QUALITY ASSURANCE -- NON-CONFORMANCE REPORT

Report No: NCR-000666

Reference Description: Base Metal Repair (buttering) without the Engineer's Approval, Longitudinal Splice Plate SA3-433

To:	AMERICAN BRIDGE/FLUOR, A JV 375 BURMA ROAD OAKLAND CA 95607	Date:	31-Jan-2010
Dear:	Mr. Charles Kanapicki	Contract No:	04-0120F4 04-SF-80-13.2 / 13.9
Attention:	Mr. Thomas Nilsson Project/Fabrication Manager	Job Name:	SAS Superstructure
Subject:	NCR No. ZPMC-0636	Document No:	05.03.06-000624

Reference Description: Base Metal Repair (buttering) without the Engineer's Approval, Longitudinal Splice Plate SA3-433

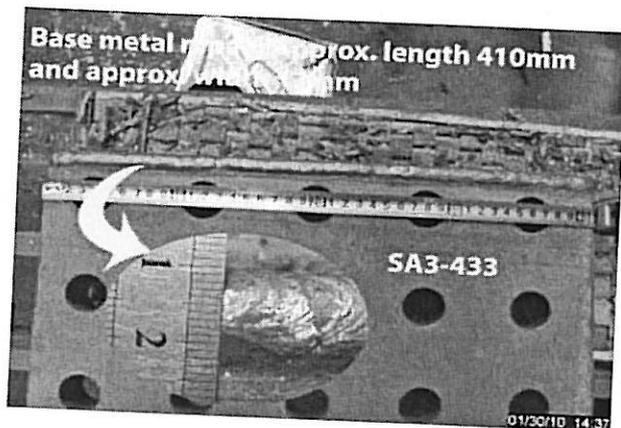
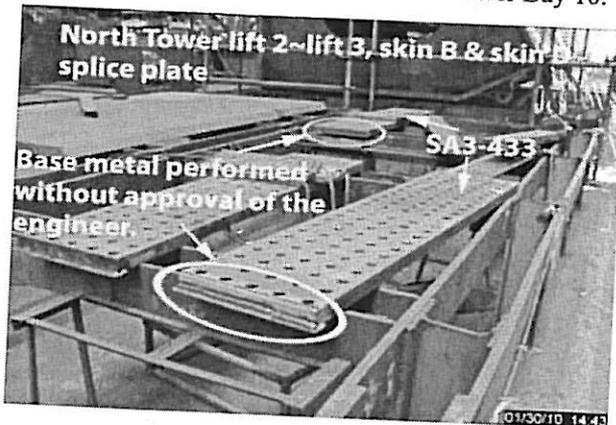
During random in-process observations of the fabrication of North Tower lift 2 ~ lift 3, skin B & skin D splice plates, Caltrans Quality Assurance (QA) observed the following issues:

- ZPMC performed deposition of weld metal (buttering/build up) by Shielded Metal Arc Welding (SMAW) process on the base metal edge of splice plates for skin B and skin D of North Tower lift 2 ~ lift 3.
- This base metal repair was performed without the approval of the Engineer.
- This build up was performed across the entire width of the edge and measured approximately 12mm thick and approximately 410mm in length.
- The material thickness is 50mm.
- The members are both identified as SA3-433.
- The plate material is designated as A709 grade 485 Non-Seismic Performance Critical Members (Non-SPCM).
- These members are located inside of Tower Bay 10.

Accept buttering based on the presence of WRR and CT inspector witnessing repair.

The maximum build up limits for weld joint correction from AWS D1.5 Section 3.3.4.1 (the lesser of 20mm or 2t) was applied to these elements, which makes the work performed in conformance to the contract specifications.

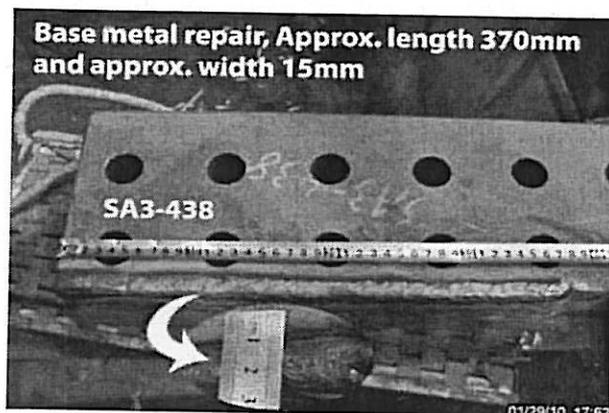
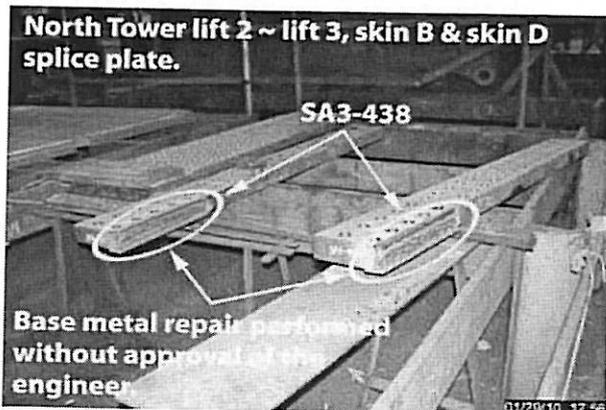
During random in-process visual inspection of North Tower lift 2 ~ lift 3, skin B & skin D splice plate, Caltrans Quality Assurance (QA) discovered the following:

- The deposition of weld metal (buttering/build-up) by Shielded Metal Arc Welding (SMAW) process on the base metal of SA3-438 splice plates.
- This build-up is measured to be approximately 15mm in width and approximately 370mm long.
- The plate thickness is 60mm.
- The material grade is A709M HPS 485 T2-Z, non-SPCM.
- This base metal repair was performed without the Engineer's approval.
- The welder is identified as 066236.
- The members are located in Bay 10.
